TECHNICAL BULLETIN

Permanent 'High Spot' Marking On Tire Inboard Sidewall – Information

MODEL 2003 MY-ON X-TYPE

D50533-ON

ILLUSTRATION 1

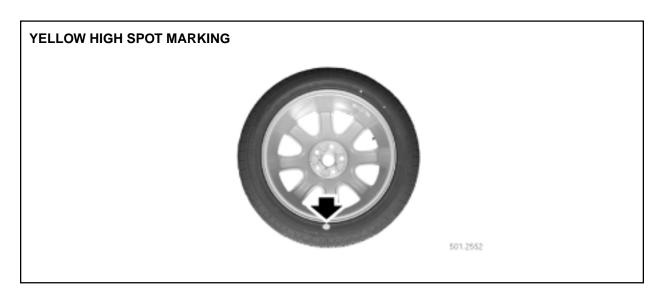
On 2003 MY-ON X-TYPE vehicles from VIN D50533, a yellow paint dot (10-13 mm in diameter) is being applied to the tire inboard sidewall to identify the high spot for radial force variation.

Engineering evaluation tests have established that when installing a wheel to the hub the position of this yellow spot can influence the vehicles level of refinement.

The optimum condition is to bias the wheel on the hub spigot towards the tires yellow dot position. To achieve this optimum condition the following process should be adhered to when installing a wheel to the vehicle.

To ensure that the optimum position of the wheel to the hub is achieved, the yellow spot (Illustration 1) must be placed in the lowest position (6 o'clock), the wheel nuts should be installed hand-tight only, and then the vehicle lowered to the ground prior to final tightening of the wheel nuts to the specified torque value.
